PREVOST

WARRANTY BULLETIN

WB23-17

DATE :	July 2023	SECTION :	07 TRANSMISSION
EXPIRATION:	July 2025		
SUBJECT :	ENGINE CRADLE HARNESS BOLT RETORQUE

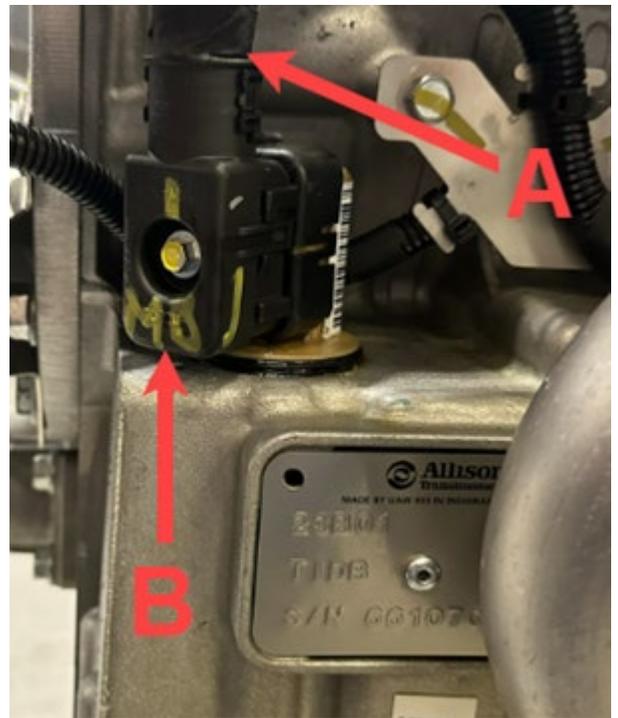
2. Locate the connector A7 on engine cradle harness that plug into transmission.

3. Retorque the bolt (B) of the connector (A) tighten the bolt to **26 lb-in.**
4. Applied torque seal on the bolt.

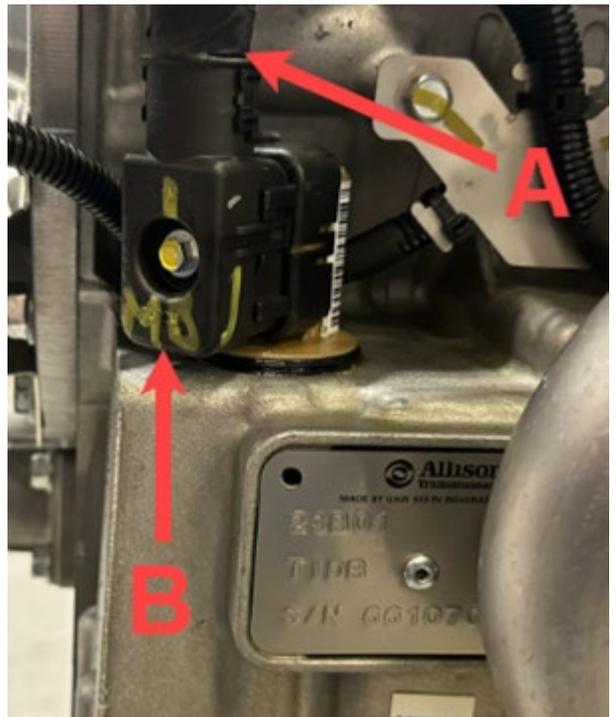
2. Locate the connector A7 on engine cradle harness that plug into transmission.

3. Retorque the bolt (B) of connector (A) tighten the bolt to **26 Lb-in.**
4. Applied torque seal on the bolt.
